SERVICE BULLETIN

Reference number:	SB-01-0443	Issued: 31 May 2017
Subject:	DB11 Rear Spoiler	
Model(s):	DB11	
VIN Range:	All	
Applicable to:	All Dealers	
Distribute to:	After Sales Manager Sales Manager	Service Manager Technician(s)

Figure 1

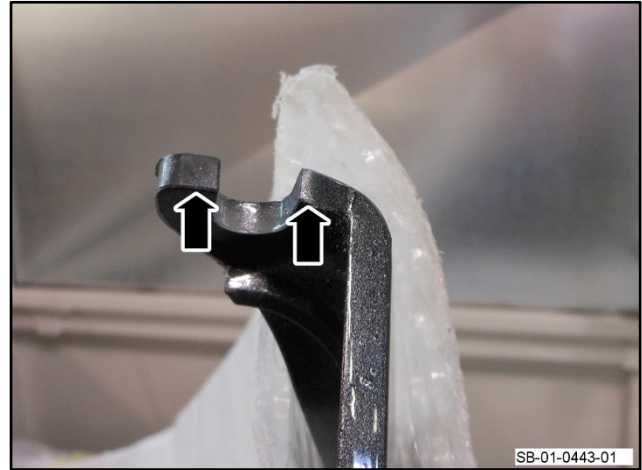
6. Do the check at Steps 3 and 4 again to make sure that the spoiler moves easily. Adjust as necessary.
7. If the clearances around the rear spoiler are the same and the spoiler still does not move easily, do the check at Step 8.
8. Do a check that there is not a quantity of paint on the two ends of the rear spoiler where it engages with the white bearings of the spoiler guide assemblies (there must be no paint on the two ends of the spoiler – refer to Figure 1).

Figure 2

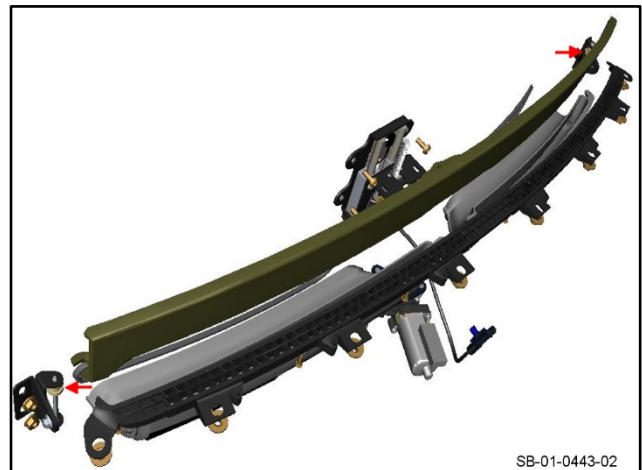
9. Do a check again that the spoiler moves easily.
10. If there is no paint on the two ends of the rear spoiler and the rear spoiler still does not move easily, continue to Step 11.
11. If the rear spoiler still does not move easily, replace the spoiler guide assemblies – refer to Figure 2 (refer to Workshop Manual procedure 01.08.DD).

Note: *From VIN L02366, we have installed modified spoiler guide assemblies, which we believe will give better performance. For early vehicles, you can order these under Part Number HY53-44298-AD and install them to replace the unserviceable assemblies. They are fully interchangeable. If you need to replace the spoiler guide assemblies of a later vehicle, you must raise an ePDR.*
